**Submission to Busselton City Council:
Proposed Structure Plan for Newport,
Port Geographe**

**Submitted by Dr R Dennis Gee
Chairman of Port Geographe Landowners
Association Inc
17 December 2018
www.portgeographe.com.au**

Proposed Structure Plan for Newport, Port Geographe: PGLOA Submission to Busselton City Council

Aviso 2018 Satellite altimetry for Southern Hemisphere - Dec 1992 to Sep 2018

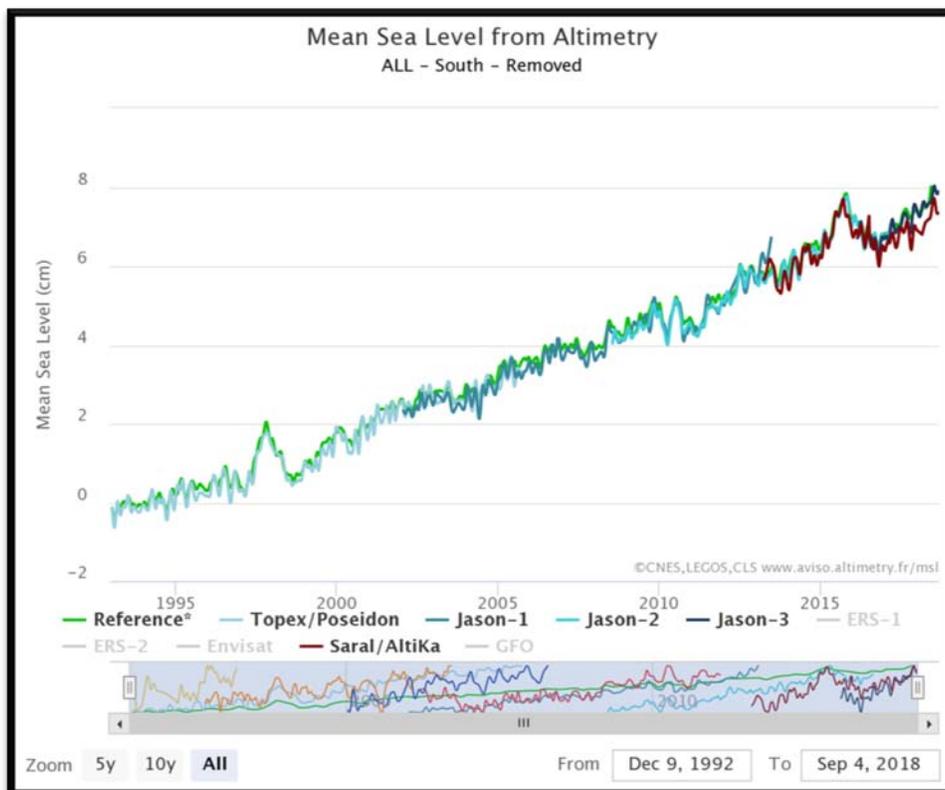
Aviso (2018) data in the above figure shows the sea-level rise for the Southern Hemisphere for the period Dec 1992 to Sep 2018 (25.85yrs) is 7.35cm, which equates to 2.84mm/y. This is significantly less than the figure advocated by Bicknell. It is generally accepted that satellite imagery is more reliable than tide-gauge records that must filter out major El Nina-type events that have amplitudes in the decimeter range.

The current figure equates to an actual rise of only 0.28 meters per century. Moreover there is no evidence for any acceleration of sea-level rise as was popularly claimed at that time. In fact there is emerging evidence of a slowing rate, as noted by Boretti (2012), and shown in recent satellite data.
